## **2021 INTERNATIONAL RESIDENTIAL CODE AMENMENTS**

### **DIVISION 2. - RESIDENTIAL CODE**

#### **Sec. 5-47. - Same—Deletions and amendments.**

Figure 307.4

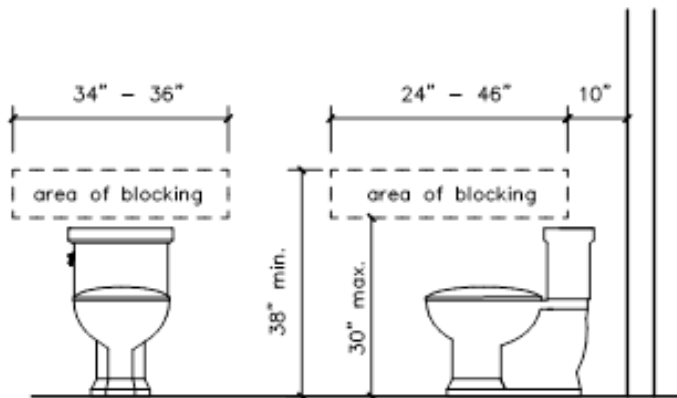
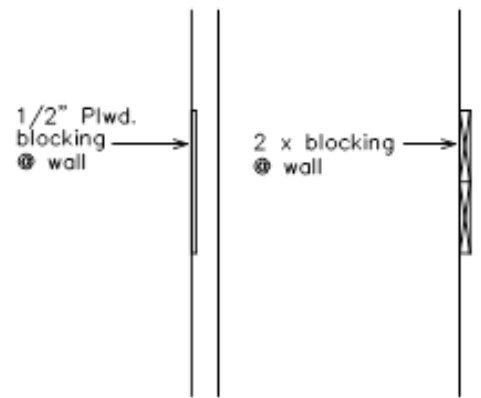
**R307.3 Blocking.** Required at one toilet at grade level. Blocking per Sec. R307.4 and Figure 307.4 shall be installed at rear wall and one wall adjacent to toilet at the lowest living level where a toilet is provided.

**R307.4 Blocking.** Blocking may be ½" plywood or equivalent or 2 x solid wood blocking flush with wall.

**Figure R602.6.1; delete the figure and insert the following figure:**

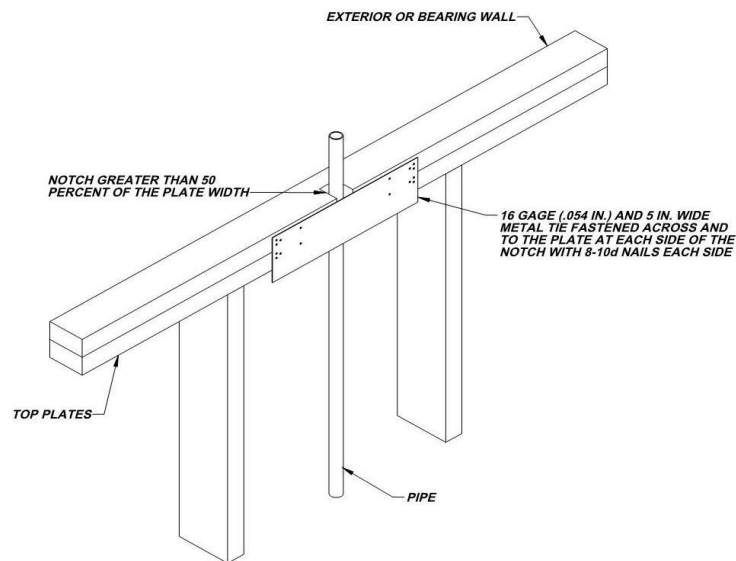
R602.6.1 Drilling and notching of top plate. When piping or ductwork is placed in or partly in an exterior wall or interior load-bearing wall, necessitating cutting, drilling or notching of the top plate by more than 50 percent of its width, a galvanized metal tie not less than 0.054 inch thick (16 Ga) and 4 ½ inches (38 mm) 5 inches (127 mm) wide shall be fastened across and to the plate at each side of the opening with not less than eight 10d (0.148 inch diameter) having a minimum length of 1 ½ inches (38 mm) at each side or equivalent. Fasteners will be offset to prevent splitting of the top plate material. The metal tie must extend a minimum of 6 inches past the opening. See figure R602.6.1. {remainder unchanged}
